**IEEE P802.15**  
**Wireless Personal Area Networks**

Project	IEEE P802.15 Working Group for Wireless Personal Area Networks (WPANs)	
Title	<b>TG3 Draft D08 to D09 changes</b>	
Date Submitted	[7 December, 2001]	
Source	[James P. K. Gilb] [Mobilian] [12707 High Bluff Dr., Suite 335, San Diego, CA 92130]	Voice: [858-436-2201] Fax: [858-436-2301] E-mail: [gilb@ieee.org]
Re:	[]	
Abstract	[This document contains the additions made by the TG3 technical editor to the draft standard D08 to produce D09.]	
Purpose	[To provide a record of the changes to the TG3 draft standard D08 to make D09.]	
Notice	This document has been prepared to assist the IEEE P802.15. It is offered as a basis for discussion and is not binding on the contributing individual(s) or organization(s). The material in this document is subject to change in form and content after further study. The contributor(s) reserve(s) the right to add, amend or withdraw material contained herein.	
Release	The contributor acknowledges and accepts that this contribution becomes the property of IEEE and may be made publicly available by P802.15.

## 1. Changes from "Austin Draft Ammendements," document 01/496r2

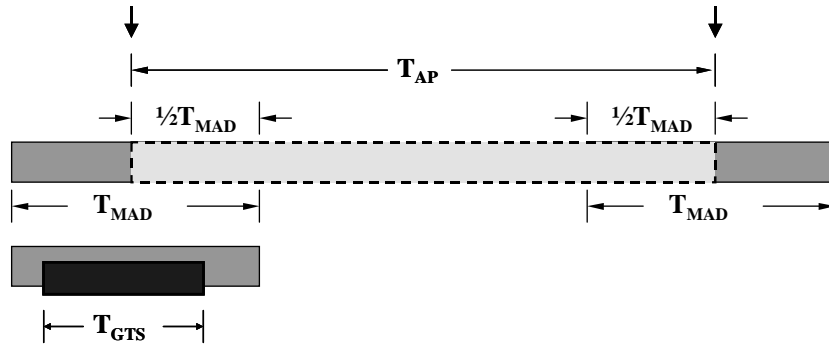
## Desired GTS time, i.e. GTS time per allocation period

- a)  $T_{DMG}$  defines the maximum amount of GTS time per allocation period that a DEV is capable of using.  $T_{DMG} > T_{GTS}$
- b) If there is unused bandwidth, the extra channel bandwidth can be divided up among DEVs based on what they can actually use.
- c) Allows channel utilization to be maximized.

Ed. action: Change the CTRB to match the figure. The new figure and new text are below:

**Figure 14—Illustration of the position of  $T_{MAD}$  within  $T_{AP}$**

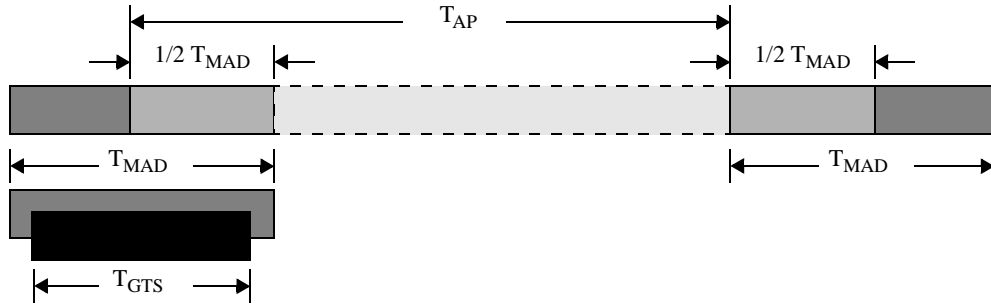
New section added to clause 8, is 8.4.3.3, text follows;

The maximum allocation delay starts before the end of the allocation period, but does not affect the PNC's reference timing of the  $T_{AP}$  period. This allows some variability in position of the GTS(s). The DEV determines this time based on the jitter requirements of the data stream that it needs to send. Figure ?? illustrates the position of  $T_{MAD}$  within  $T_{AP}$ . The

$T_{GTS}$  time is the total amount of slot time that needs to be allocated within the  $T_{MAD}$  time entered around the start of the  $T_{AP}$  interval.

**Figure 38—Superframe structure**

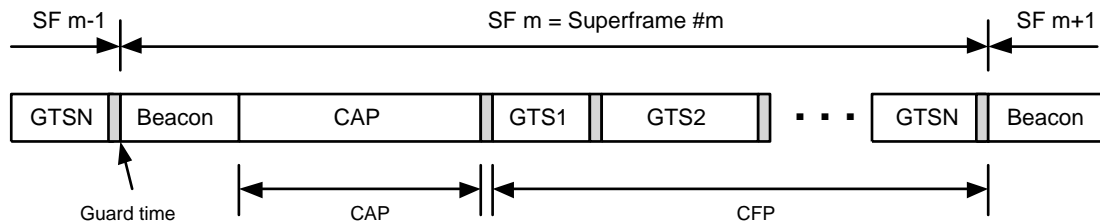
Issue 334, ADH: Figure 49 Superframe structure does not include guardtime

Resolution: Update figure.

Ed. action: New figure added, to D09, shown below:
